**CORRESPONDENCE COVER SHEET  
WASTE PERMITS DIVISION  
TEXAS COMMISSION ON ENVIRONMENTAL QUALITY**

Date: April 25, 2019  
 Facility Name: City of Kingsville Landfill  
 Permit or Registration No.: MSW 235-C

Re: City of Kingsville Landfill – Kleberg County  
Municipal Solid Waste (MSW) - Permit No. 235C  
Permit Amendment Application – Notice of Deficiency  
Tracking No. 23301130, 23458984, and 24040819; RN102334570/CN600674246

On behalf of the City of Kingsville and in response to the Texas Commission on Environmental Quality's (TCEQ) March 27, 2019 Notice of Deficiency (NOD) letter, we hereby submit the enclosed response regarding the Permit Amendment Application for the above referenced MSW facility.

**FIGURE:  
 III.2-2**

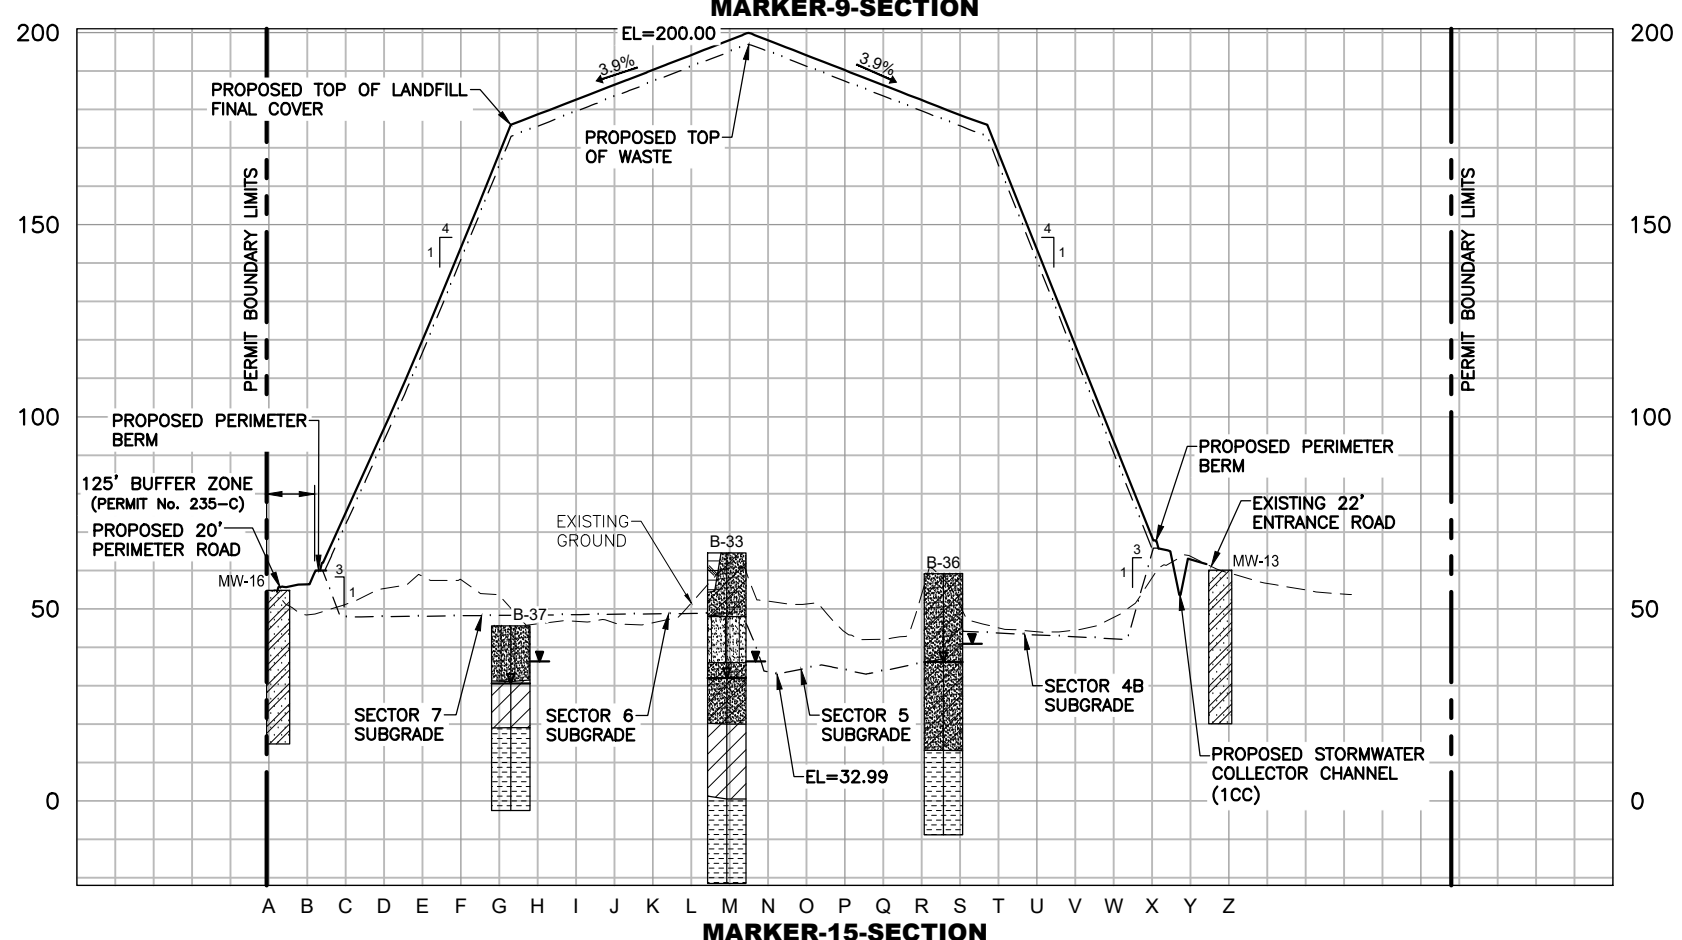
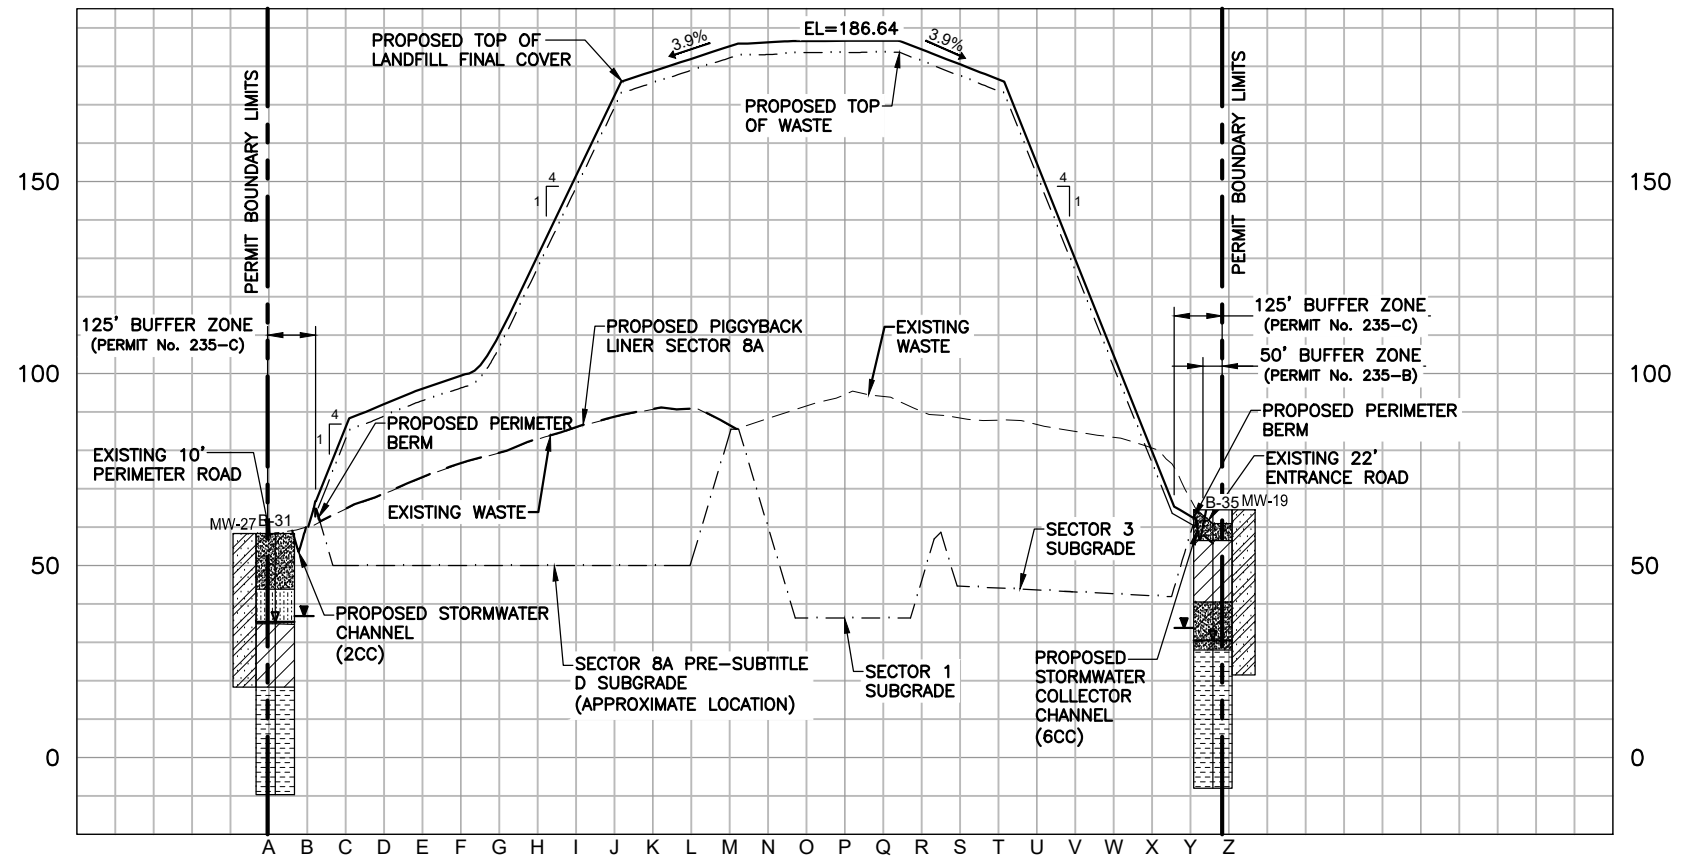
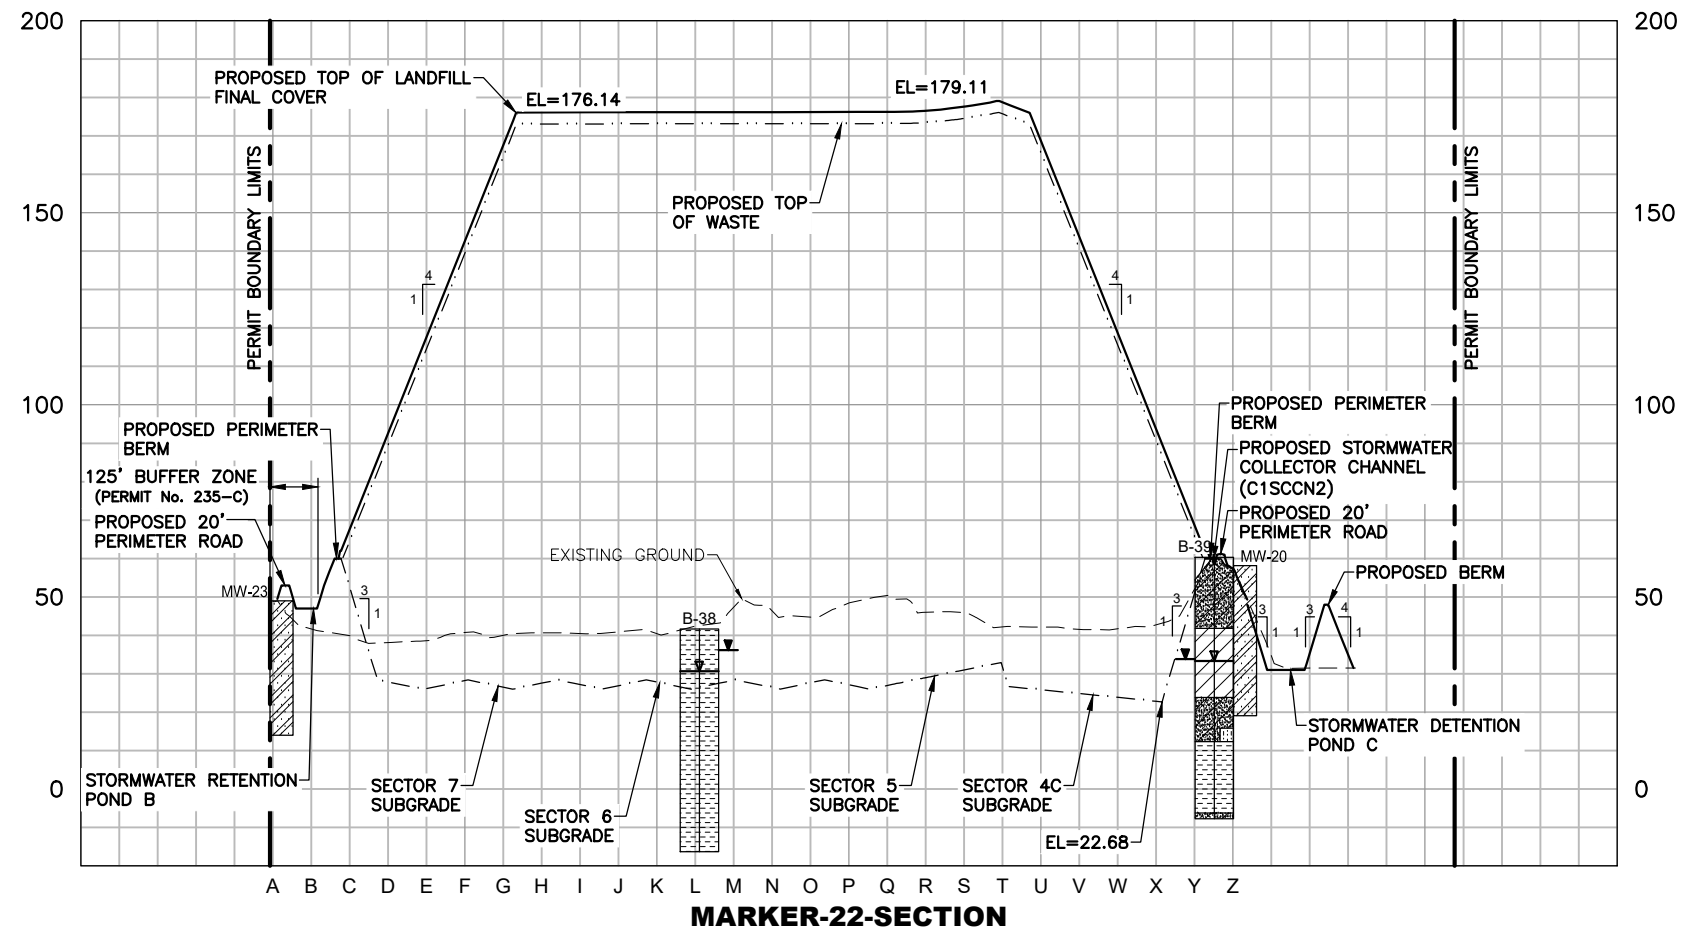
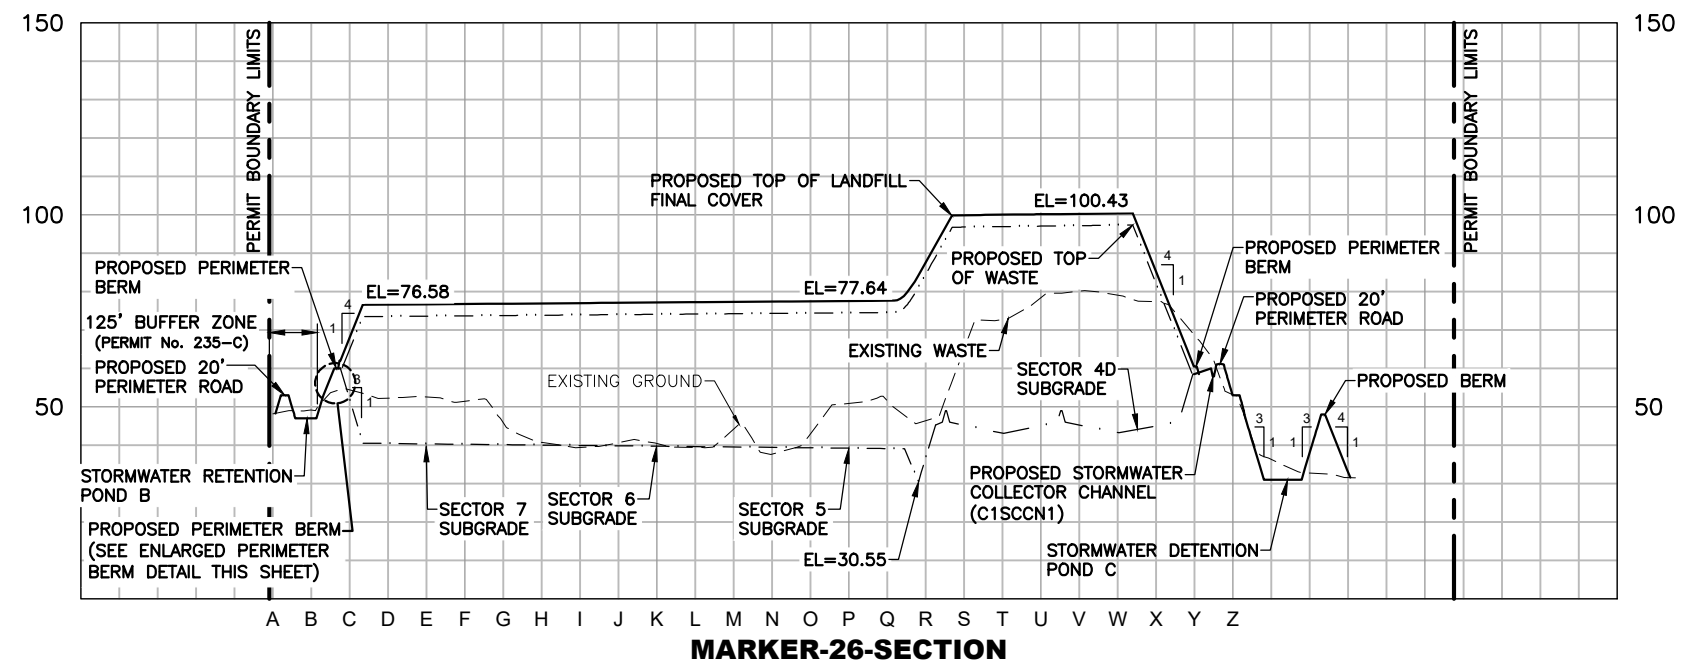
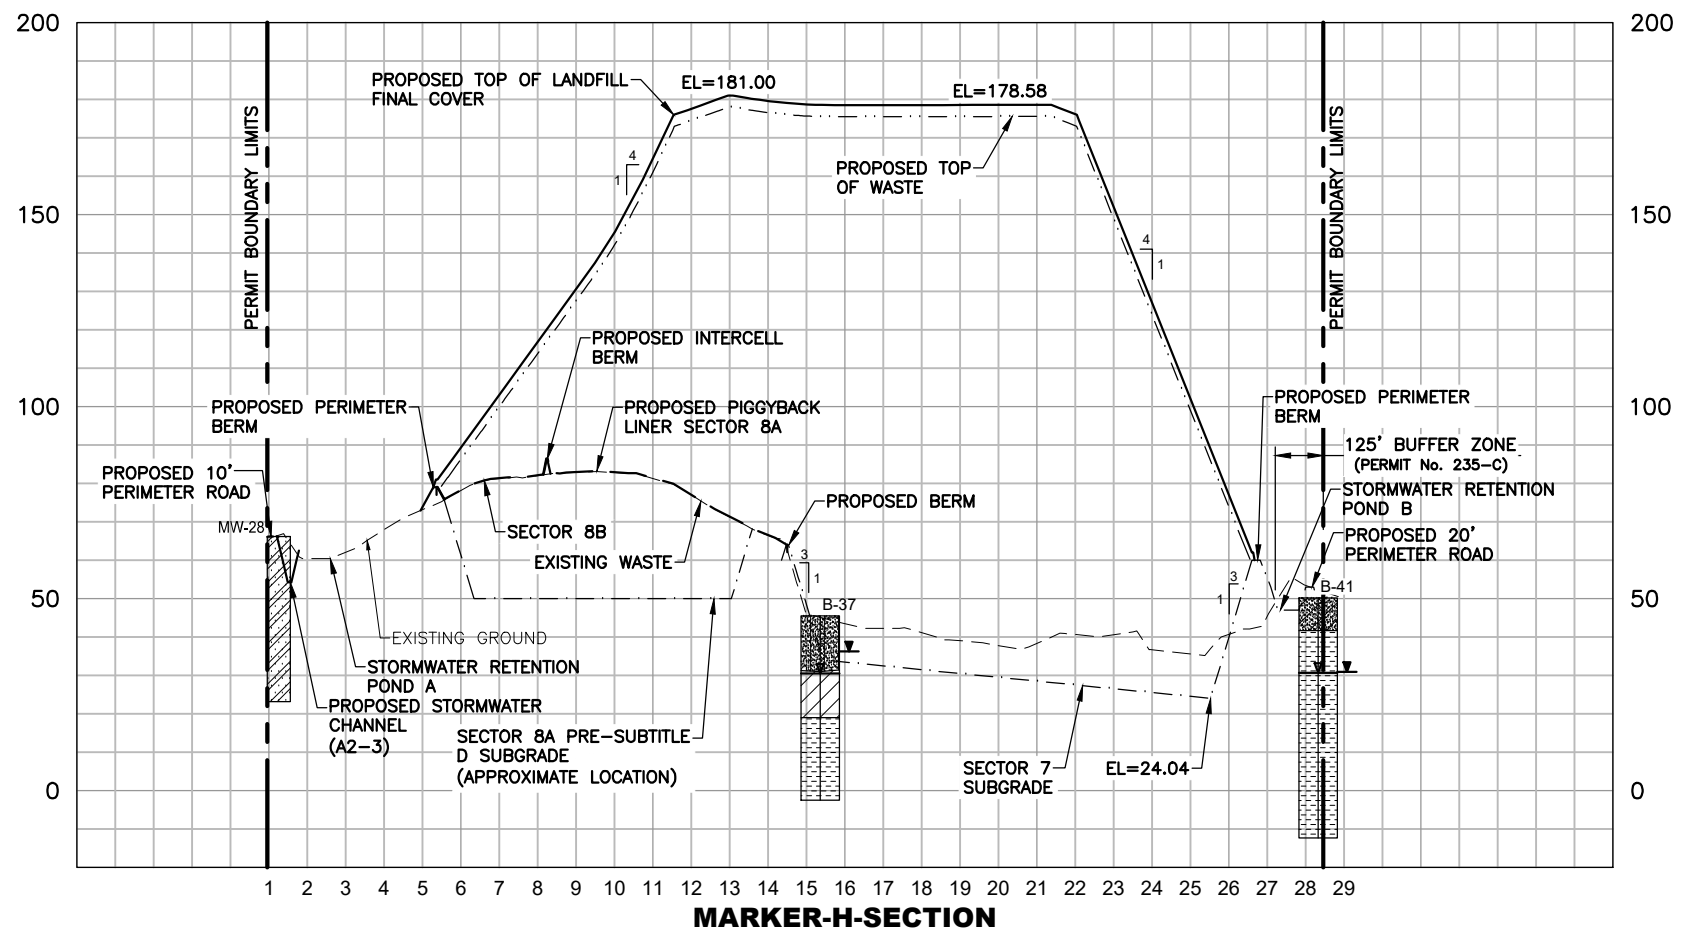
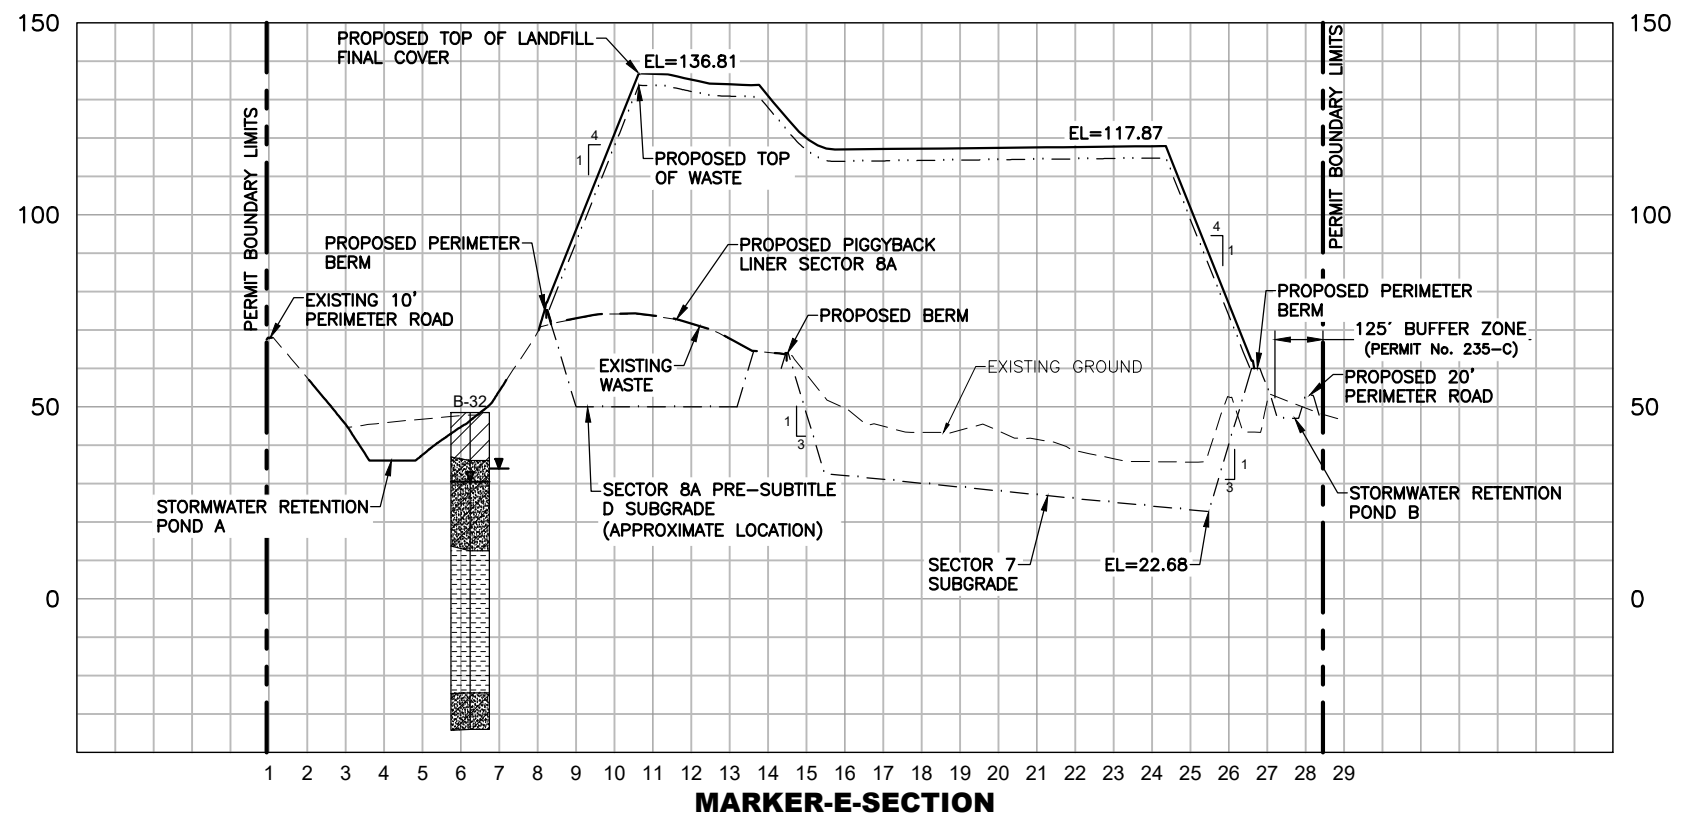
T12	356	Part III	330.63(d)(4)(E)	Vol 1, Att 2, Fig III.2-1 thru III.2-5	Incomplete	Provide cross sections showing gas vents or wells, and groundwater monitoring wells.	Figures III.2-2 to Figure III.2-5 have been revised to show gas probes and groundwater monitoring wells.
T13	358	Part III	330.63(d)(4)(F)	Vol 1, Att 2, Fig III.2-1 thru III.2-5	Incomplete	Revise Att. 3 to provide details of liners tie-in for piggyback overliner into existing liner in active sectors (Sector 8 to Sector 1), and into new liner in proposed sectors (Sector 8 to Sector 6).	Figure III.3-5 has been added to Part III, Attachment 3 to show details of the Sector 8 piggyback overliner tie-in to Sector 1 (Detail 15) and the Sector 8 piggyback overliner tie-in to Sectors 6/7 (Detail 16).
